Additional Comments on the Pantex Plant Radiological Investigation Report

Brice Smith, Ph.D. and Arjun Makhijani Ph.D.

Prepared for Sustainability in Technologies, Agriculture and Nature's Diversity (STAND)

September 20, 2004

Figure 1: Graph of the measured values of total uranium and U-238 activity in soil at the Pantex site. The solid line indicates the trend that should be expected if it is assumed that essentially 100% of the mass of the uranium is due to U-238 as is the case in natural or depleted uranium.

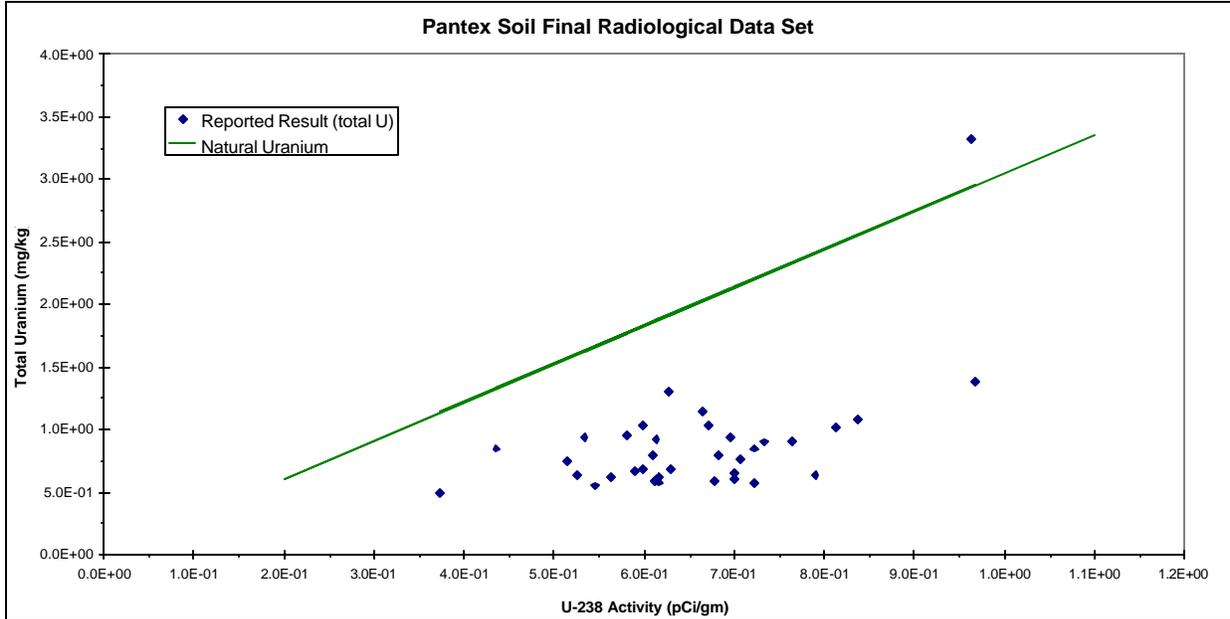
In natural or depleted uranium nearly 100% of the uranium mass is attributable to U-238 and thus both forms of uranium should follow the solid line in Figure 1. With the exception of a single data point, all of the reported measurements show a U-238 activity in excess of that expected for natural or depleted uranium which is not physically possible. In addition, the data show no apparent strong correlation between U-238 activity and total uranium measured which further indicates that the measurements are not reliable and should not be used as part of a characterization of the Pantex site. This conclusion is further supported by the fact that more than 75% of the 1,375 soil samples analyzed for total uranium were recorded as being non-detections while just 0.26% of the 1,910 soil samples taken for U-238 were recorded as non-detections.

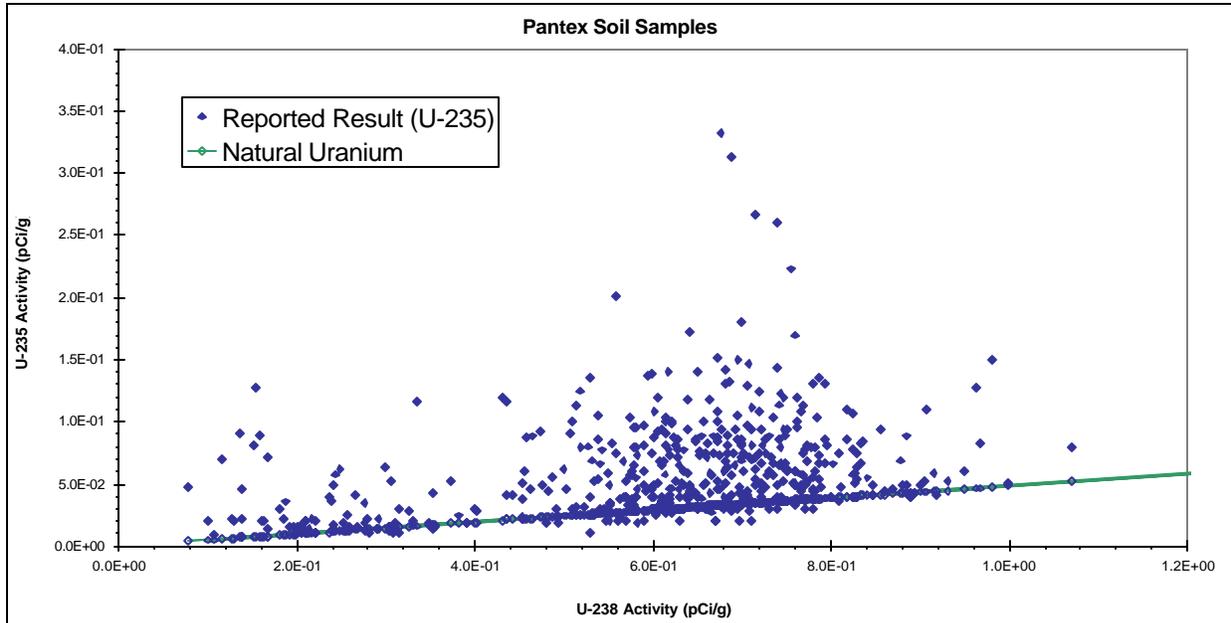
As with the data used to determine background, the isotopic ratios of U-235 to U-238 in the soil measurements are not consistent with natural or depleted uranium, and appear to show no clear correlation between the two isotopes. Since samples of depleted uranium should lie below the solid line in Figure 2, the data make even less sense in the context of Pantex operations. If these data were to be believed, it would indicate the presence of predominantly enriched uranium on site. The average ratio of U-235 to U-238 from these data is found to be 0.11 ± 0.09 . The average is more than 2.2 times the expected ratio for natural uranium. However, the large standard deviation (80% of the average) indicates the significant spread in the data and makes it yet more difficult to say anything meaningful from this collection of measurements. It is our expert opinion that the soil data for U-235 as presented in the Final Radiological Data Sets is not physically reasonable, and that it is consistent with our previous conclusions regarding a likely problem with the QA/QC program at the laboratories performing the analysis.

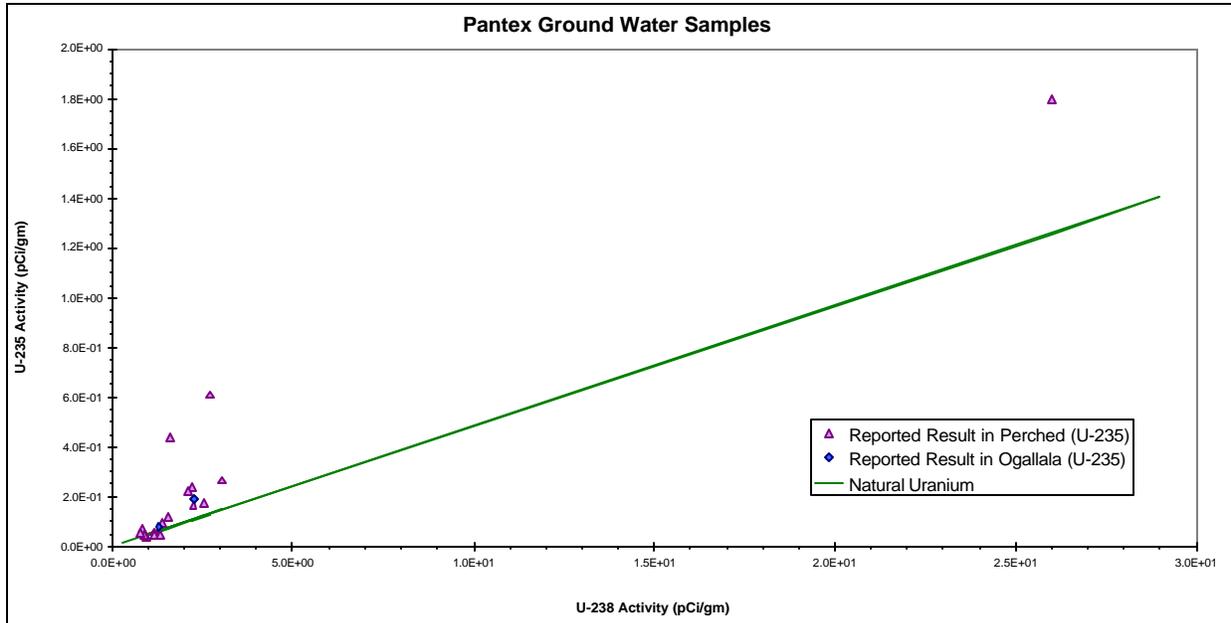
From the data in Figure 3, indications of the same type of anomalous ratio can still be seen as was found in the soil and in the samples analyzed to determine background. The majority of the samples that deviate significantly from natural uranium are above the line which would be appropriate for enriched uranium, but the scatter does not show any clear trend. For the surface water, there were only 4 samples taken and 3 were designated as non-detections. The indications of continued faulty laboratory analysis and/or data collection procedures, and the limited number of samples analyzed for U-235 support our recommendation for a new sampling of the Pantex site and analysis by a recently certified laboratory.

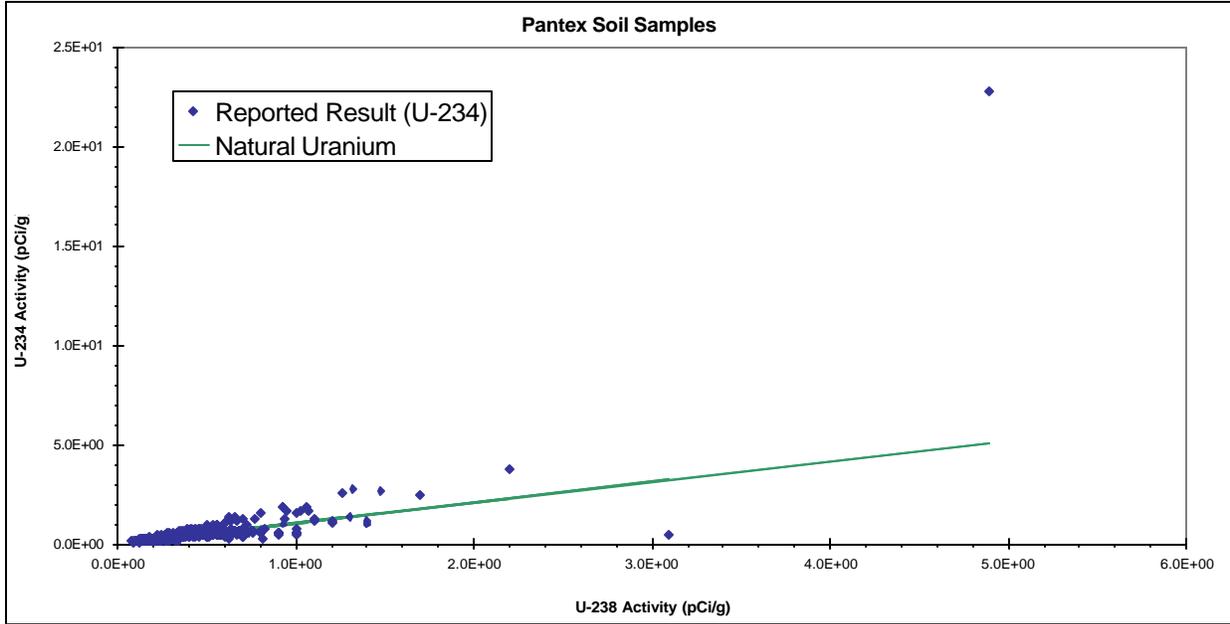
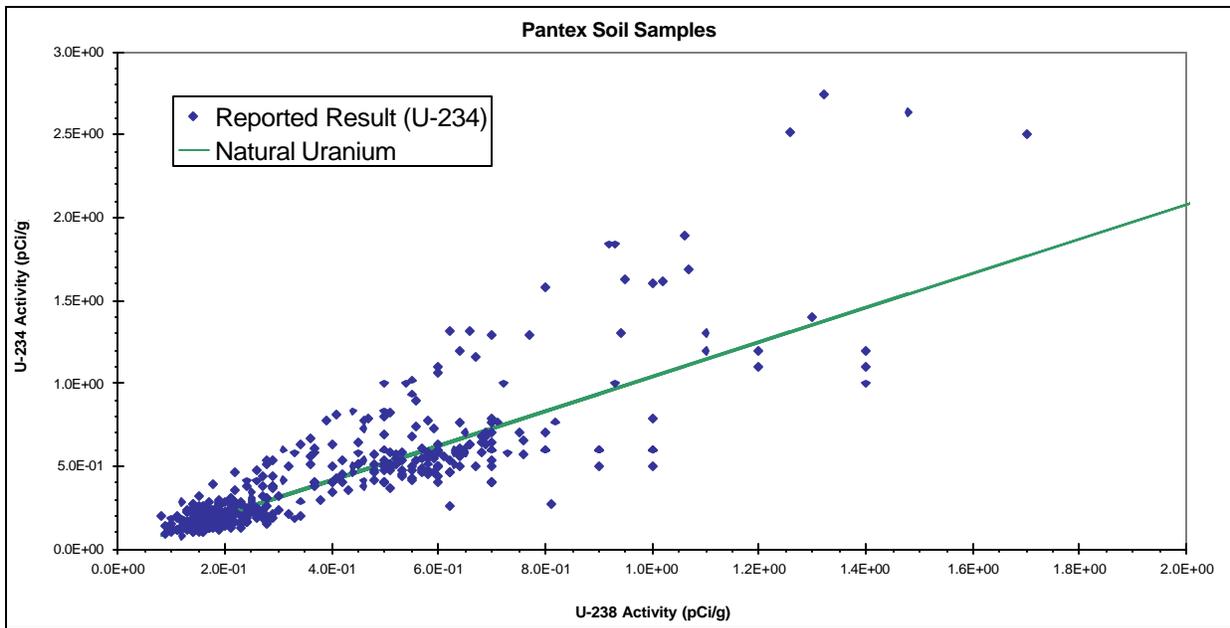
For uranium in secular equilibrium the ratio of U-234 activity to U-238 activity should be close to one. For the measurements given in the Final Radiological Data Sets, the average ratio is found to be 1.03 ± 0.33 . The only serious question surrounding this ratio is connected to the measurements of U-235 discussed above. In our opinion, the U-235 data are not reliable as it stands, particularly given the similarly inconsistent results for the isotopic ratios from the samples taken in order to determine background. However, in light of the indication of possible enriched uranium in the U-235 soil samples analyzed we note that there are 22 samples that have a ratio of U-234 to U-238

activity that is more than 3 standard deviations above the average which might indicate the presence of some level of enriched uranium as well. Only 2 of these 22 samples (Sample ID 20011107D01204 from the Building 12 Sump and Sample ID PTX07-AE-3D08-0-1 from SWMU 57) have U-235 results reported as detected, but both of these samples show ratios that are more consistent with enriched uranium than natural or depleted uranium.
